SUBJECT: AMENDMENT NO. 20 TO FACILITY OPERATING LICENSE NO. NPF-58
(TAC NO. 69525)

PERRY NUCLEAR POWER PLANT, UNIT NO. 1

Amendment No. 20
License No. NPF-58

ATTACHMENT TO LICENSE AMENDMENT NO.20

FIGURE 3.2.1-1

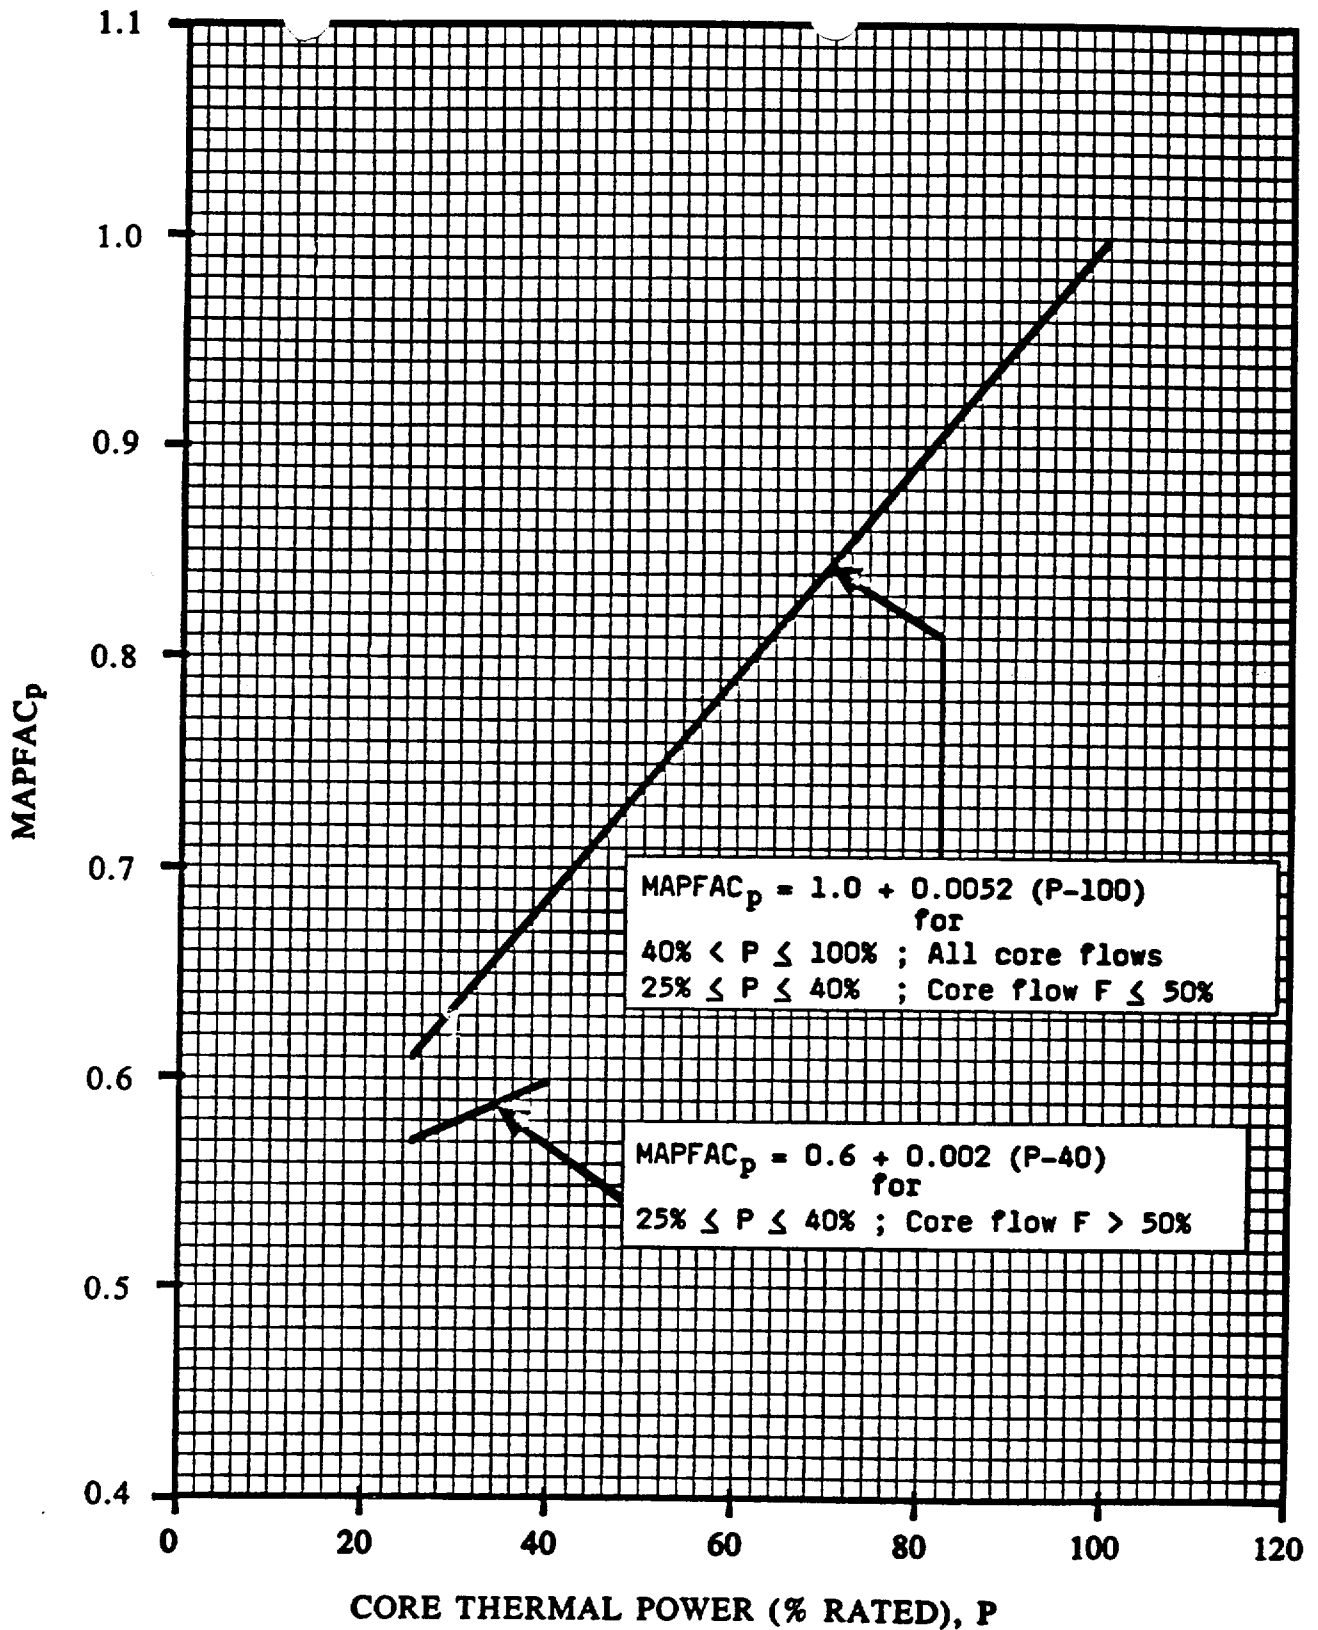
Modification of the $MAPLHGR$ versus average exposure for each fuel type in Cycle 2. Figures 3.2.1-1, 3.2.1-2, 3.2.1-4 and 3.2.1-5 were renumbered, Figure 3.2.1-3 was deleted. Figures 3.2.1-5 and 3.2.1-6 were added. These changes have been discussed above and are acceptable. Also, as discussed above, the new Figure 3.2.1-1 was modified to extend the curve to the 20% of rated core flow line. This change is acceptable.

Figure 3.2.1-5

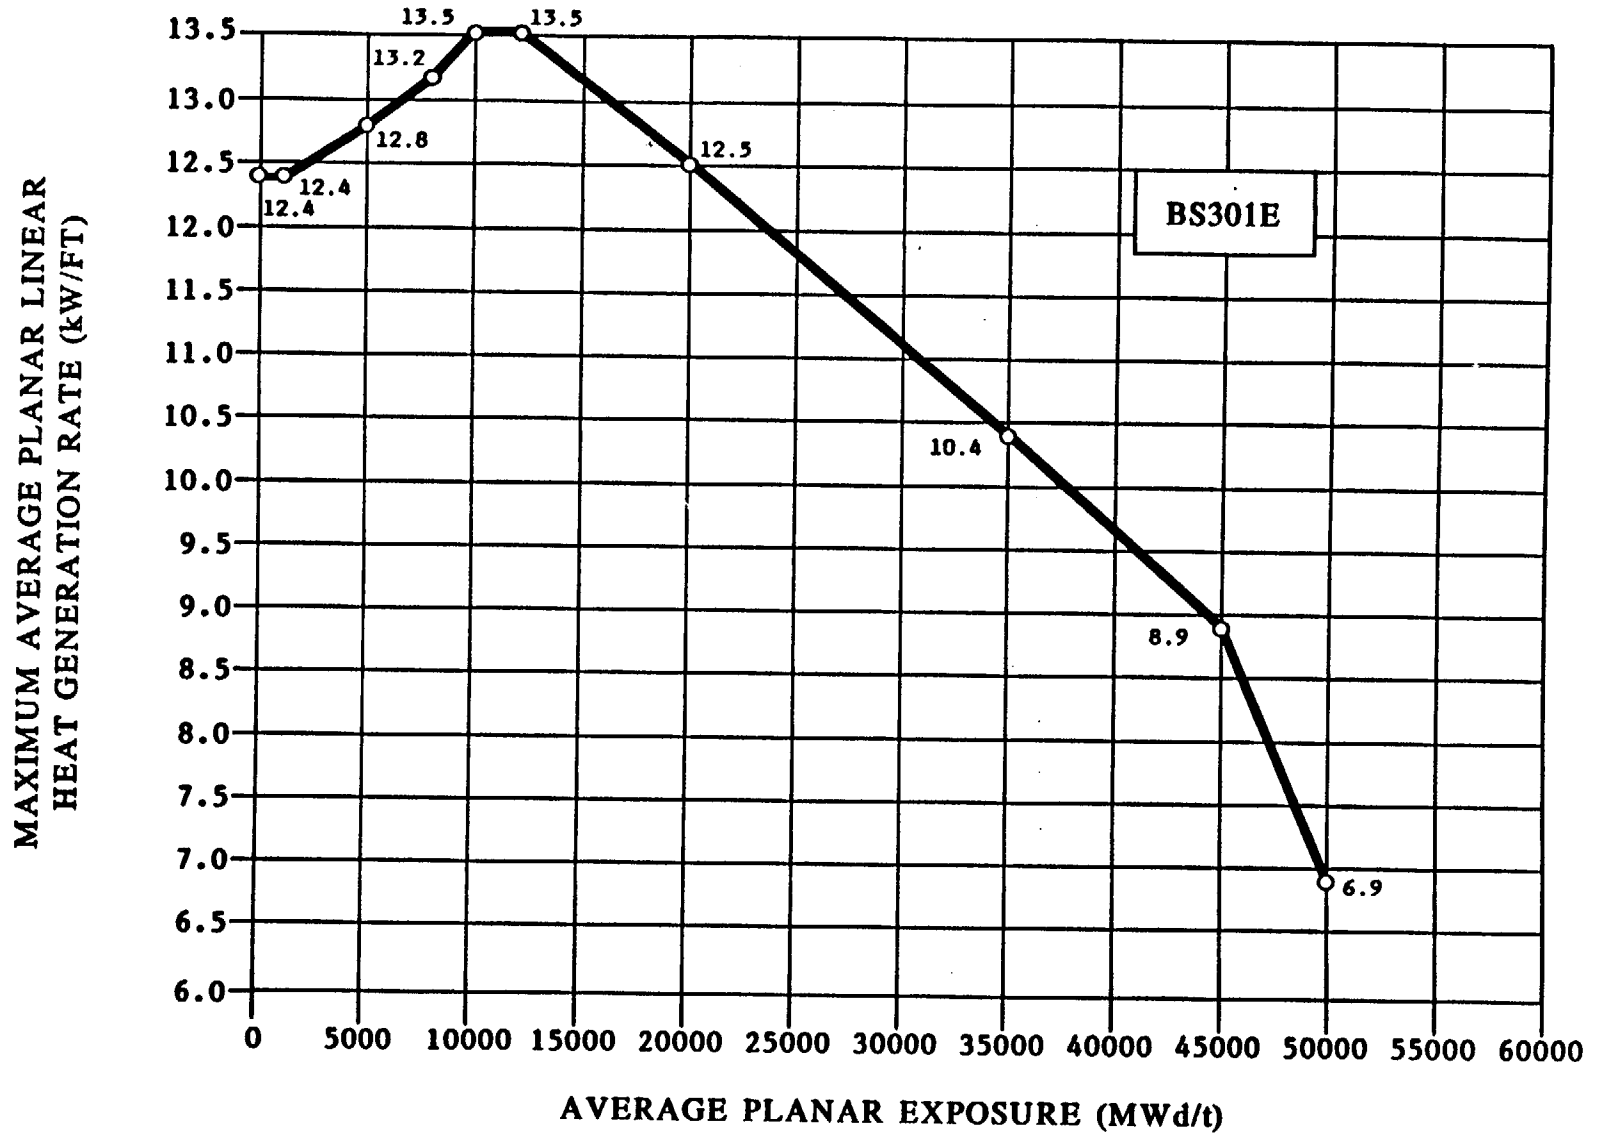
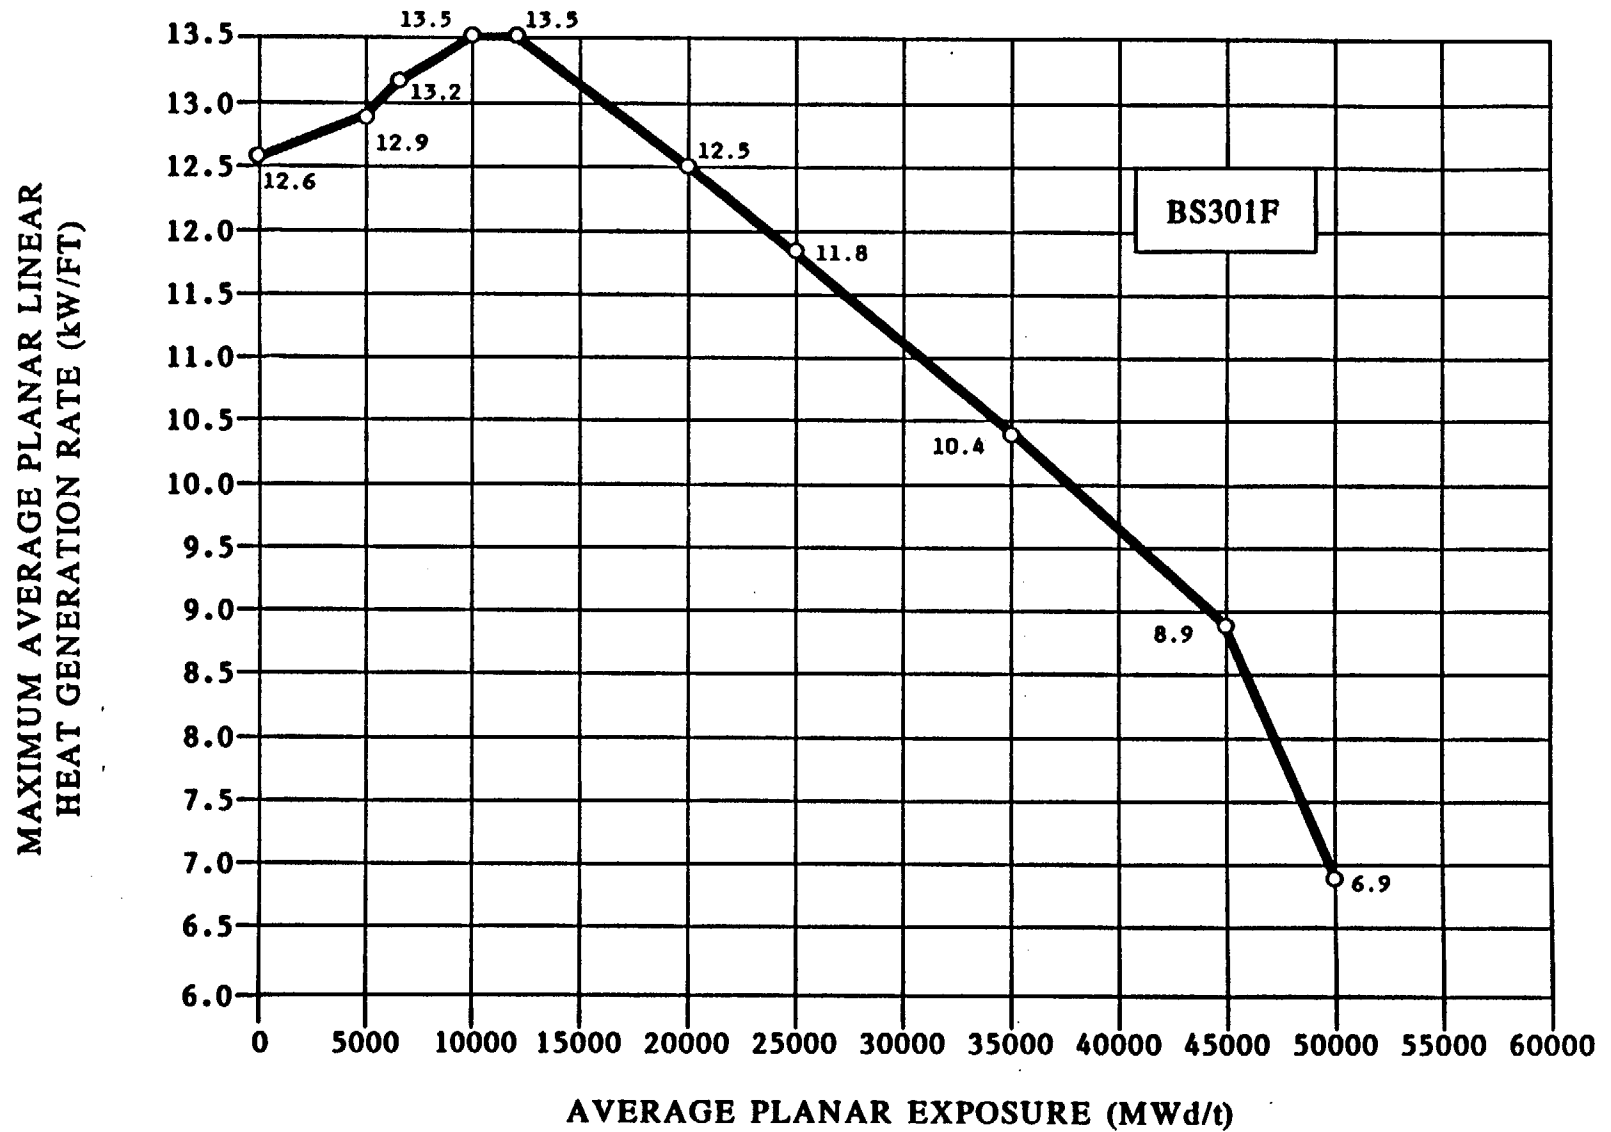
This amendment increases the minimum critical power ratio (MCPR) from 1.06 to 1.07, adds two limiting lattice most-limiting average planar linear heat generation rate (MAPLHGR) curves to the TS to account for new fuel types being used this cycle, and deletes the MAPLHGR curve for natural uranium bundles.

FIGURE 3.2.2-1

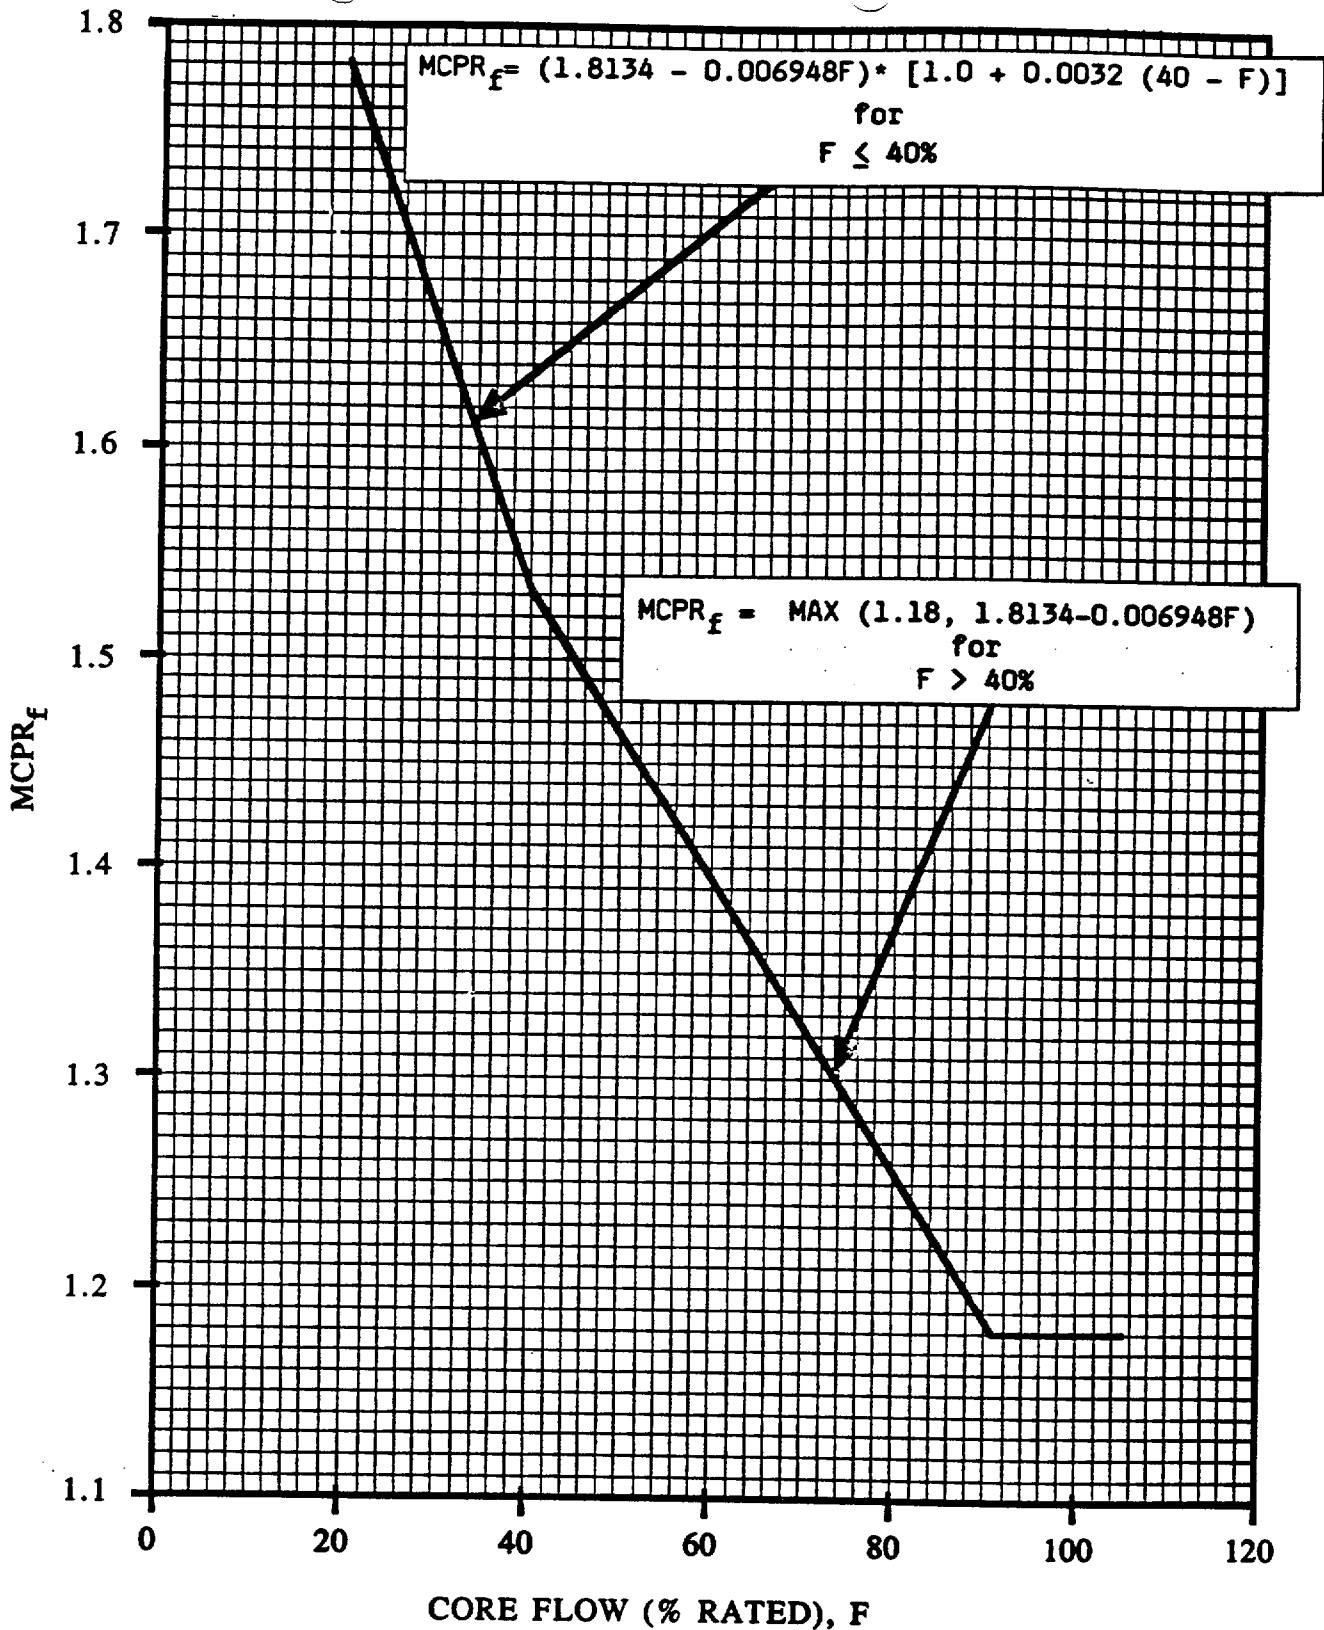
5. Figure 3.2.2-1 has been revised for the flow dependent minimum critical power ratio, $MCPR_f$, to correct the extrapolated value for Cycle 2 operation. As discussed above, this change is acceptable.

FIGURE 3.2.2-2

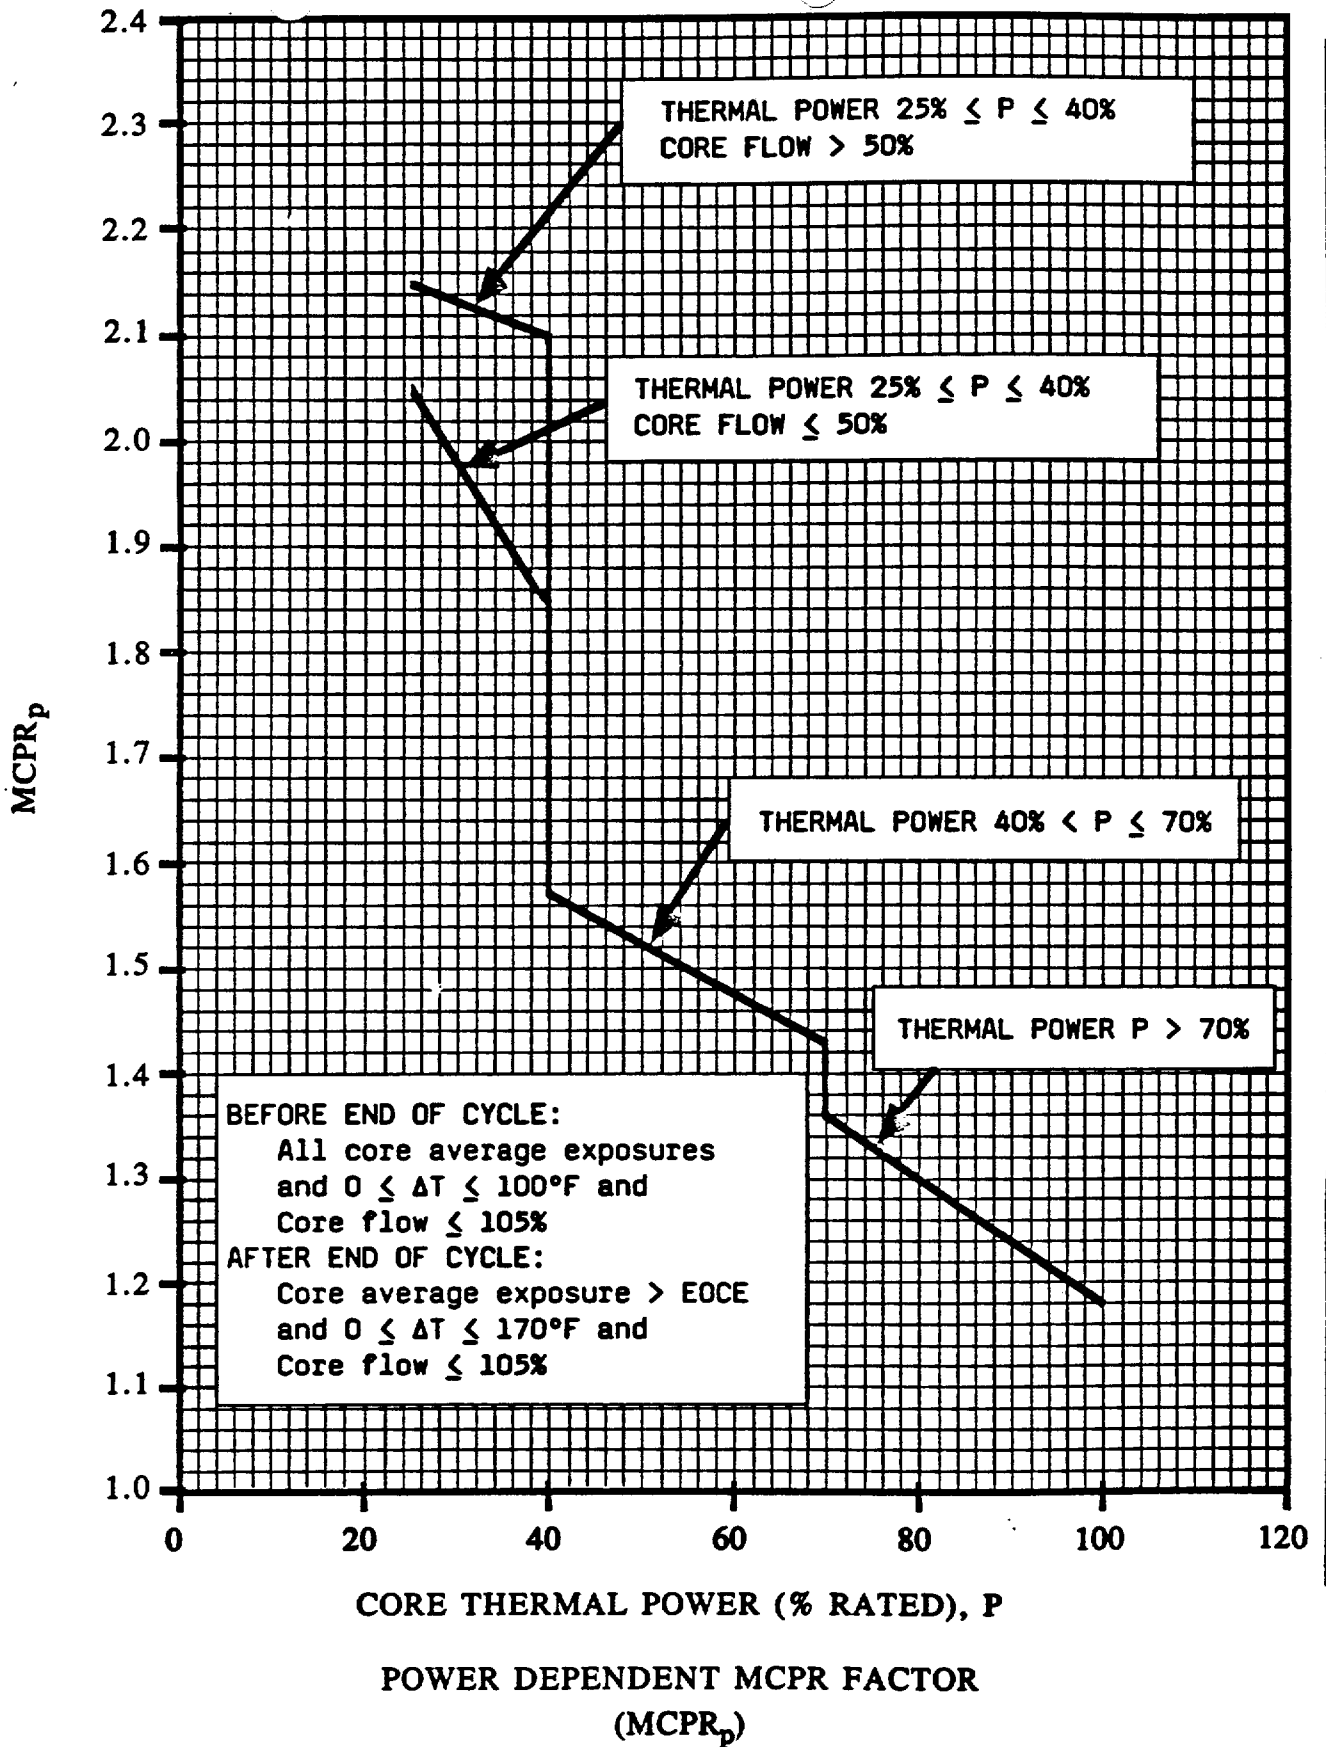
Figure 3.2.2-2 also reflects the required MCPR values resulting from the analysis performed to justify operation with the feedwater temperature ranging from 420°F to 320°F at 100% RATED THERMAL POWER steady state conditions, and also beyond the end of cycle with the feedwater temperature ranging from 420°F and 250°F.

Changes in Figure 3.2.2-2 as discussed above reflect the revised $MCPR$. The changes are acceptable.
